APPROVED MINUTES OF THE MEETING

May 6, 2010

Project: Alaskan Way Viaduct and Seawall Replacement

Phase: Design Update

North Building: 6th and Harrison

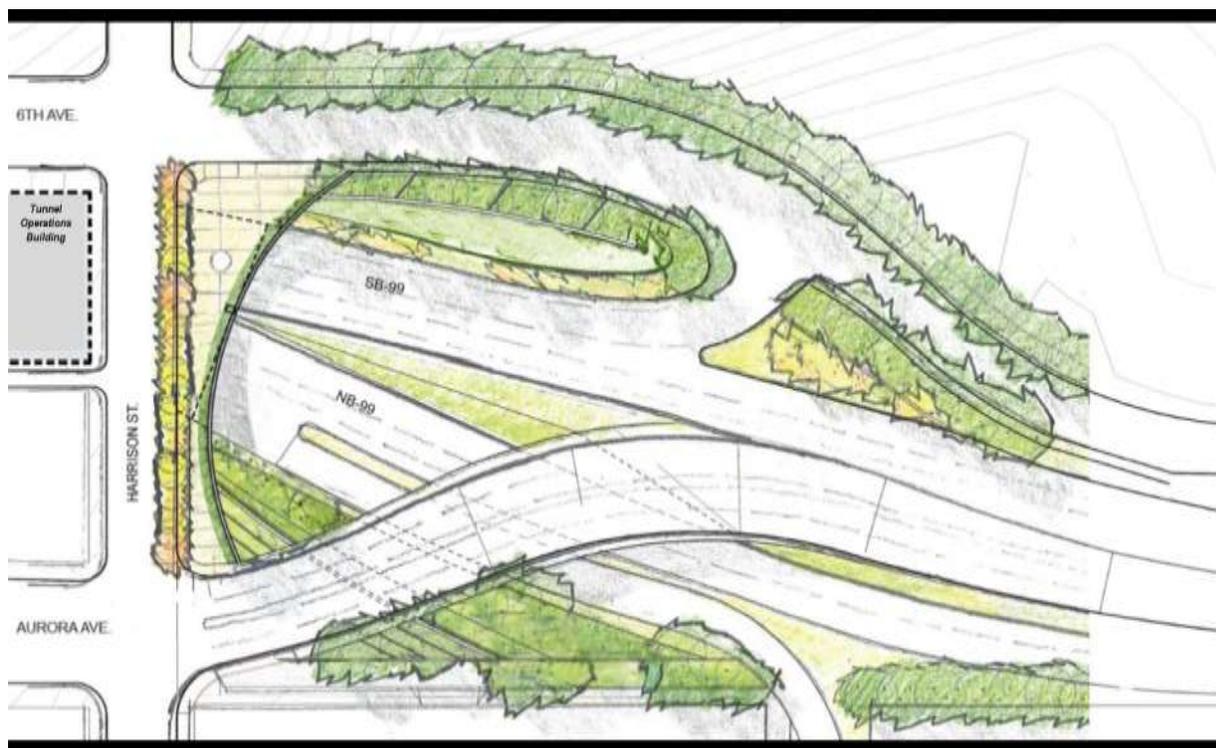
I had a question about the stacked buildings and the opening of it of the roof so that it can be more transparent.

With a guardrail on the roof, you might have an opportunity to open that roof up a bit more and keep that language of translucency.

There are two incredibly important joints in the area over the portal arc; the east one still looks like it needs to be developed.

For the building, the walls have elegance to the patterns and I like the idea of the changing from vertical to horizontal. You might want to borrow a little bit of the patterning for the buildings. You might want to address the color of the building. I like the large doors you have on one building.

I am also a little a little disappointed in what you have showed us for the streetscape. I think that it needs to be much more developed. I also question not using street trees around the box as it might make the space more a place that people actually want to be. I think that the parking configuration green screen might need to be rethought.

As far as the building structure, I think that the massing is strong, but the materials need to work together. Consider taking one more look to the north side shop area.

The plinth on which the glass box sits on Harrison is high. Some thought about this needs to be developed. On the portal, I'm not sure the terracing is working here on this side.

We need to have the area closed off because it needs to project the equipment. We may need to put acoustic information up on the ceiling.

We will be working with the design build contracts to make sure that they do work together and are consistent. There will not be separate people looking at the design.
